# **8 INDUSTRIAL DRIVE ADDITION**

SP# 05-23

## **STAFF REPORT**

Re: Town of Hudson Planning Board Review  
8 Industrial Drive Addition Site Plan, 8 Industrial Drive  
Tax Map 161 Lot 40; Acct. #1350-188  
Reference No. 20030249.22290

**OVERVIEW PLAN**

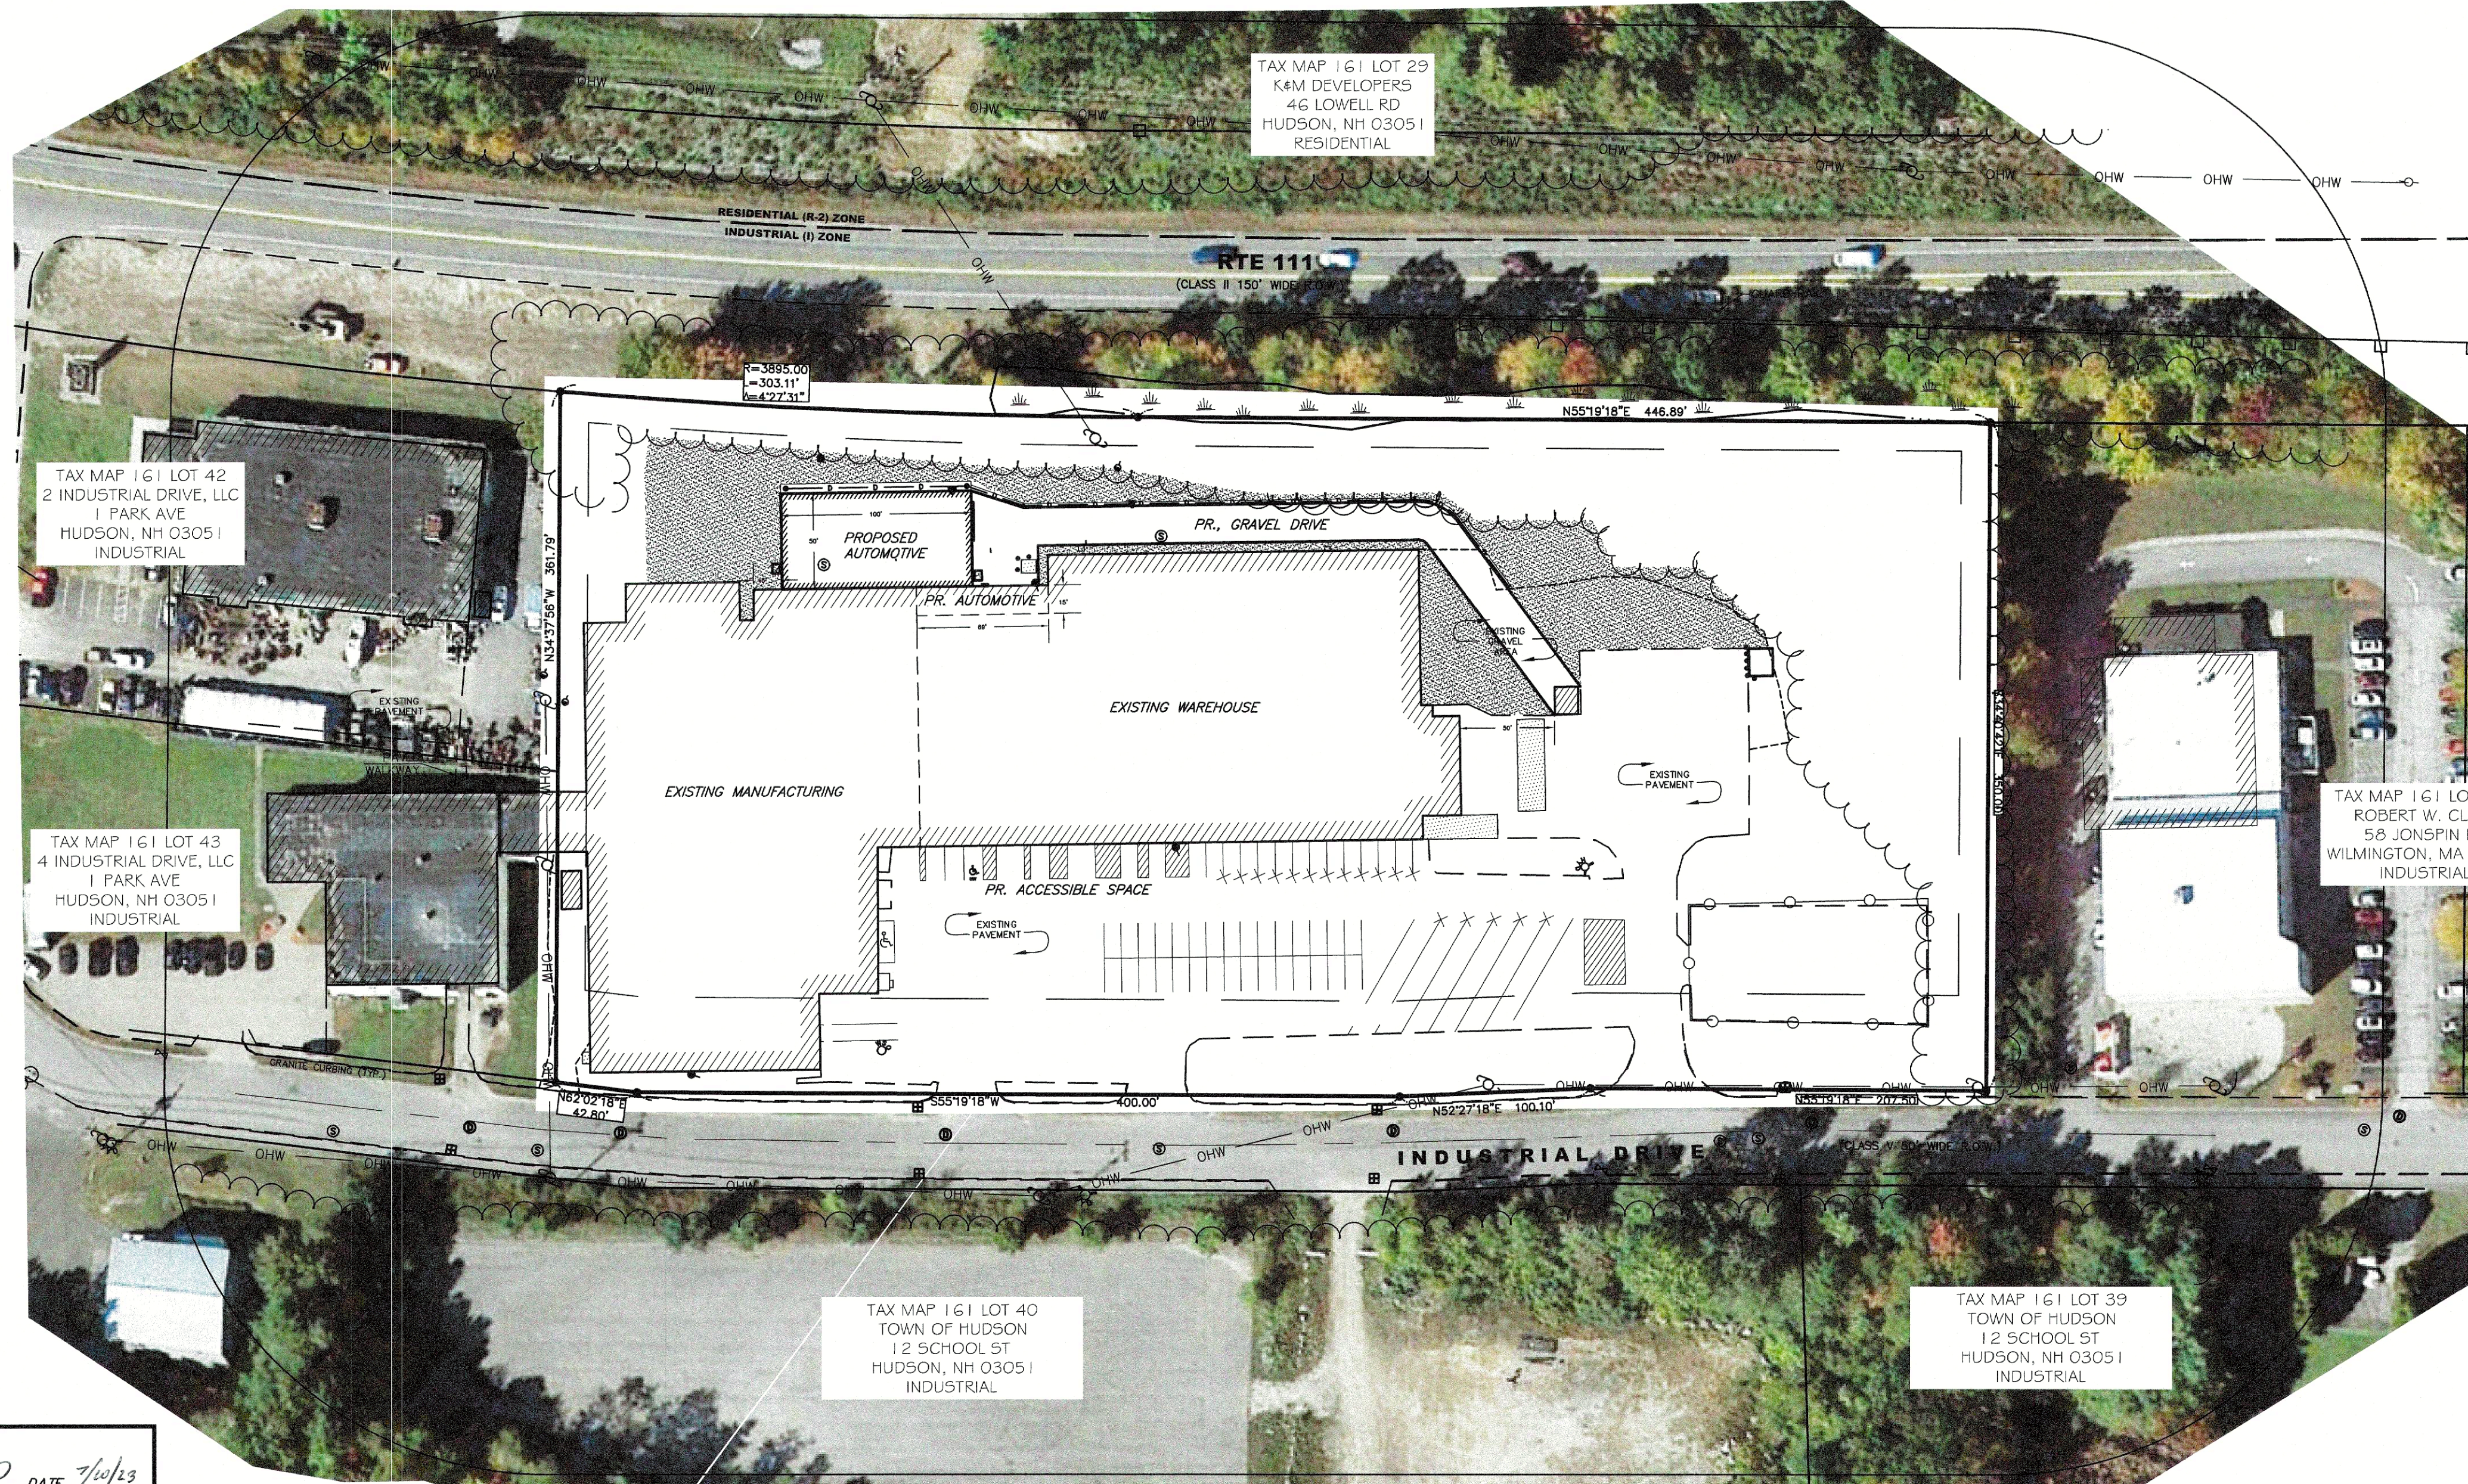
- f. HR 275-9.C.(11). The applicant has shown one existing handicap accessible parking space for the site in the existing parking lot and has not proposed any modifications to this lot. We note that one handicap accessible space does not meet the minimum requirement.

Reply: On the Cover Sheet we show an additional accessible spot for a total of 2 accessible spaces on site as required per ADA regulations.

**TAX MAP 161 LOT 41**  
**SEWER PLAN AND PROFILE**  
**8 INDUSTRIAL DR SITE PLAN AMENDMENT**  
 LOCATED AT:  
**8 INDUSTRIAL DRIVE**  
**HUDSON, NEW HAMPSHIRE**  
 PREPARED FOR/OWNER:  
 MDP REALTY ASSOCIATES, LLC  
 9 OLD DERRY ROAD  
 HUDSON, STATE

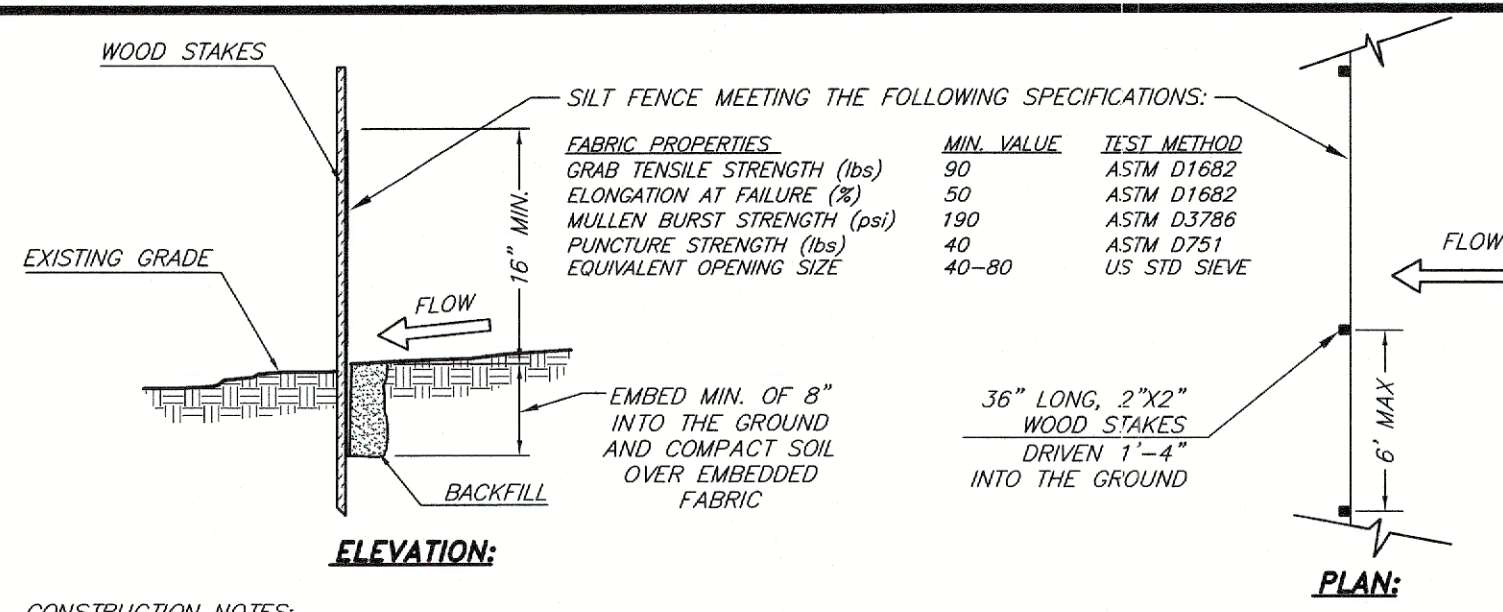
- b. HR 275-9.E. The applicant has shown an existing sewer manhole and piping under the proposed building addition area. The applicant should provide more information on how this manhole will remain accessible within the addition.

5. The plan proposes to install a building over an 8" sewer service. Applicant shall provide a cross section of the pipe in relation to the proposed foundation.

Reply: A sewer profile has been added to the plan set which shows the existing sewer line and the proposed addition.

Reply: We have included a plan and profile with the plan set.

**GRAVEL DRIVE & INFILTRATION TRENCH DETAIL**  
NOT TO SCALE

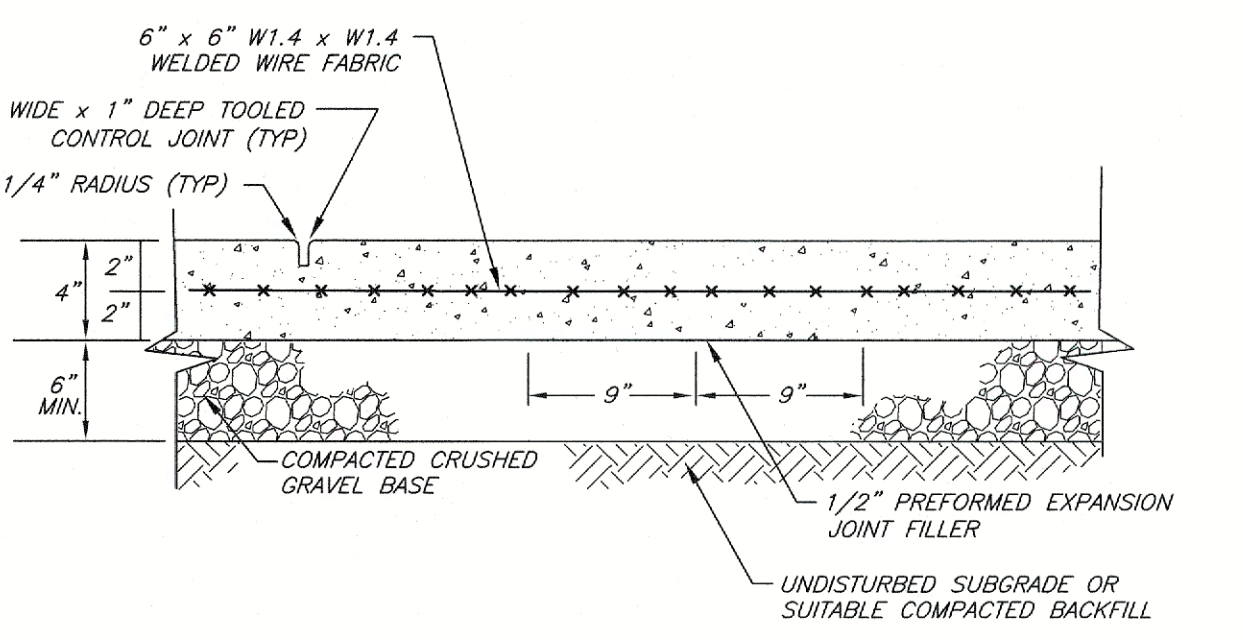
- c. HR 275-9.A. We note the drainage computations as well as the plans refer to the gravel driveway as “pervious”. The applicant should provide additional information on how this gravel is classified as pervious and is going to free-drain, given the following

- i. The Gravel Drive Detail illustrated on plan sheet 3 calls for the gravel to be installed above compacted subgrade.
  - ii. The gravel driveway is assumed to be installed and compacted, as NHDOT item 304.3 is typically installed.

- c. HR 275-9.A. We note the drainage computations as well as the plans refer to the gravel driveway as “pervious”. The applicant should provide additional information on how this gravel is classified as pervious and is going to free-drain, given the following

- i. The Gravel Drive Detail illustrated on plan sheet 3 calls for the gravel to be installed above compacted subgrade.

Reply: We have updated the design to show an infiltration trench along the northern side of the drive.

**ROOF DRIP INFILTRATION TRENCH DETAIL**  
NOT TO SCALE

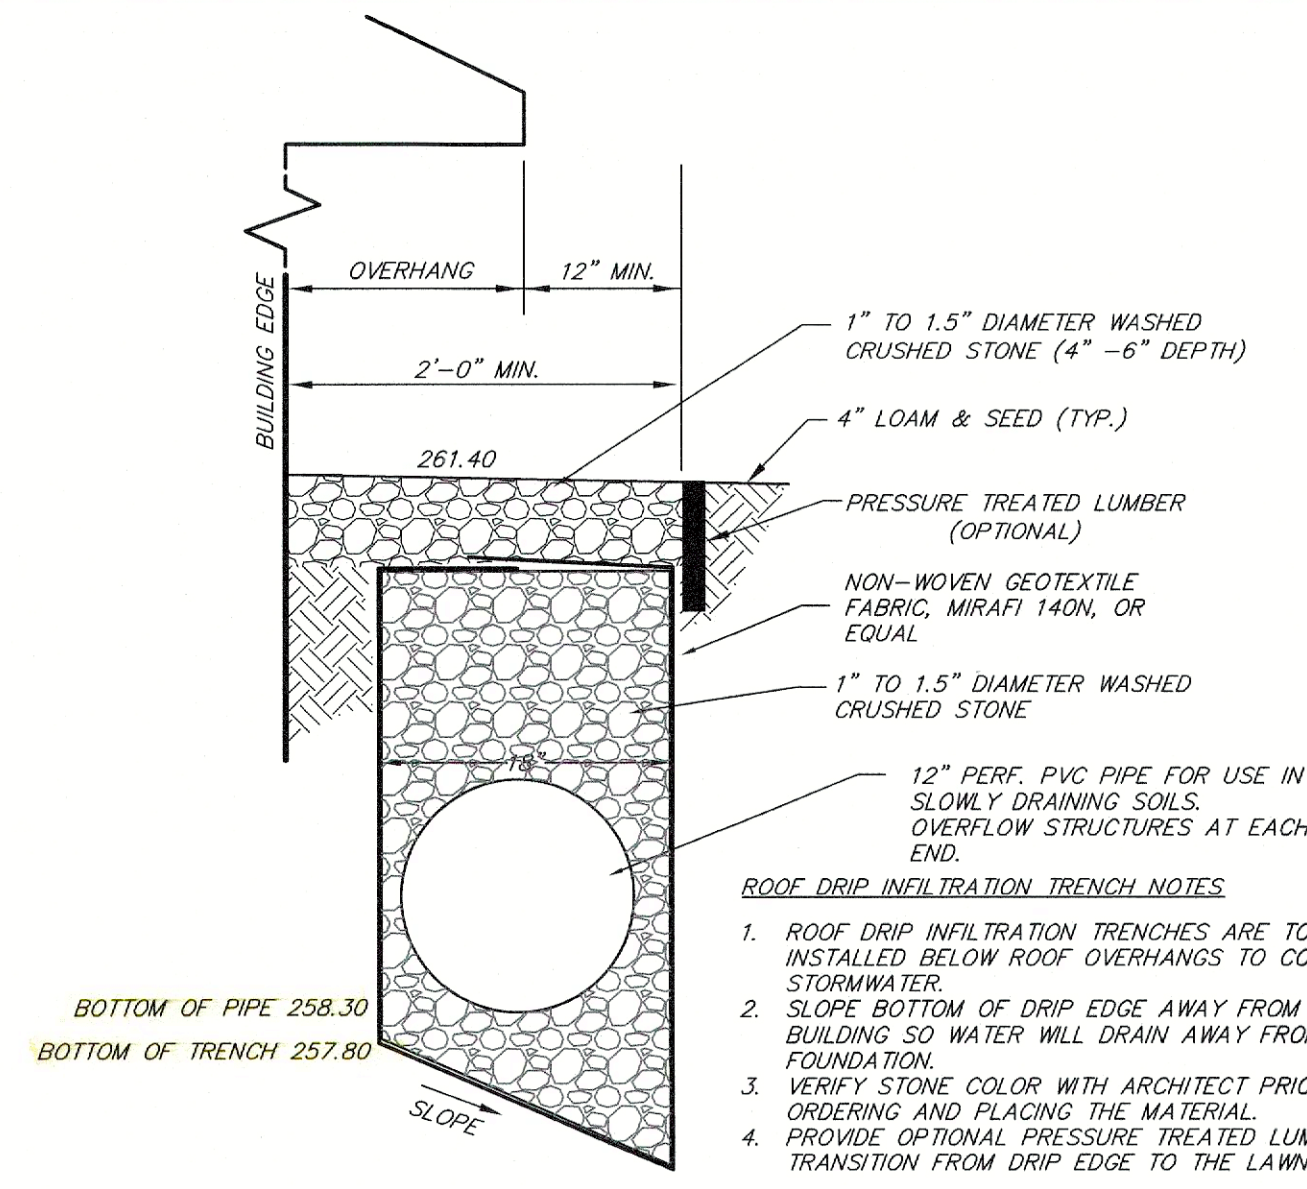
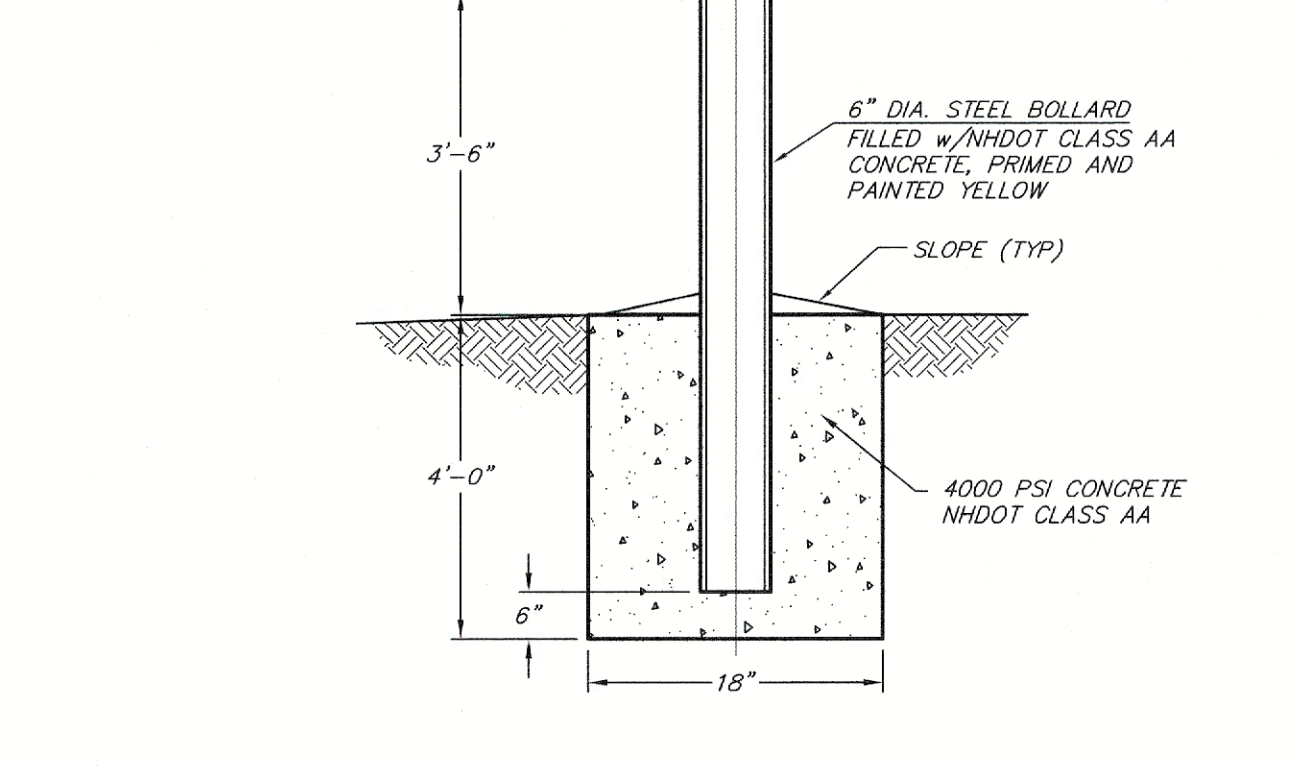
- h. HR 275-9.A.3. The Roof Drip Infiltration Trench Detail notes the 12” perforated pipe is optional. The applicant should remove the “optional” term or remove the pipe from the drainage computations.

- h. HR 275-9.A.3. The Roof Drip Infiltration Trench Detail notes the 12" perforated pipe is optional. The applicant should remove the "optional" term or remove the pipe from the drainage computations.

Reply: We updated the note on the detail.
